Interactive comment on “The Power Curve Working Group’s Assessment of Wind Turbine Power Performance Prediction Methods” by Joseph C. Y. Lee et al.

Joseph C. Y. Lee et al.

Received and published: 20 November 2019

Fig. 1. As in Fig. 11 in the manuscript, but using NMAE. The features generally match those in Fig. 11.

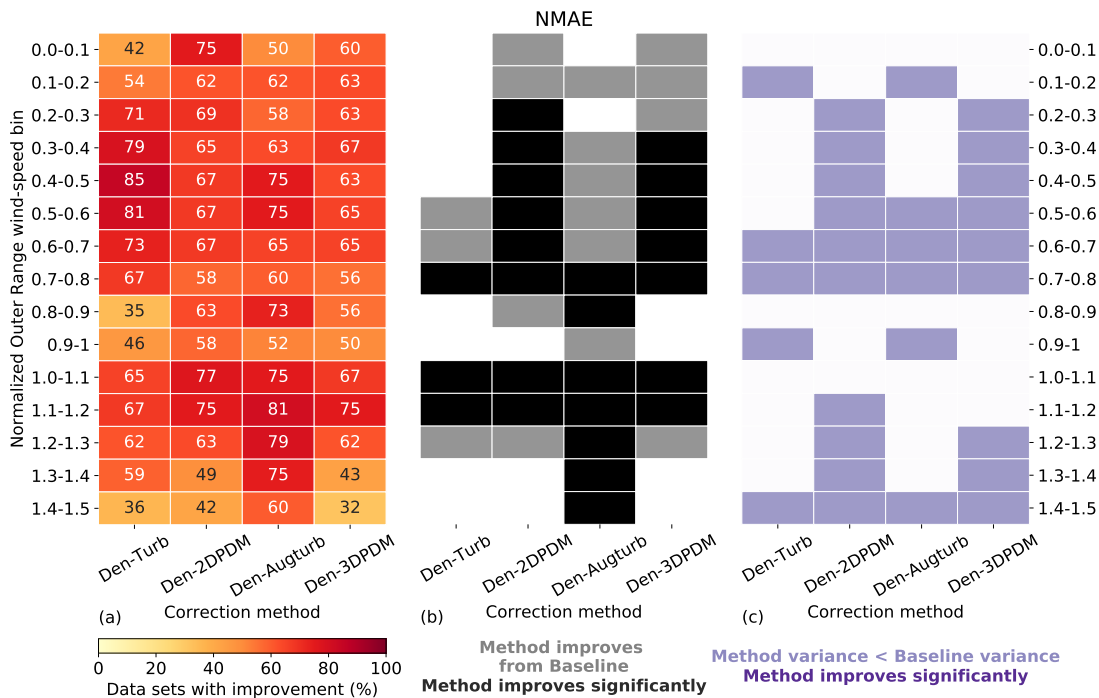
NMAE is useful to evaluate the prediction error in specific, short-term events, while the metric does not provide information on the direction of bias. In this study, our focus is on average bias rather than the cumulative error of a correction method. In fact, the statistical results from NMAE are analogous to those of NME, please see the Fig. 1 below. As the reviewer suggested, we will assess NMAEs in future study, when we have large sample size and higher quality data.
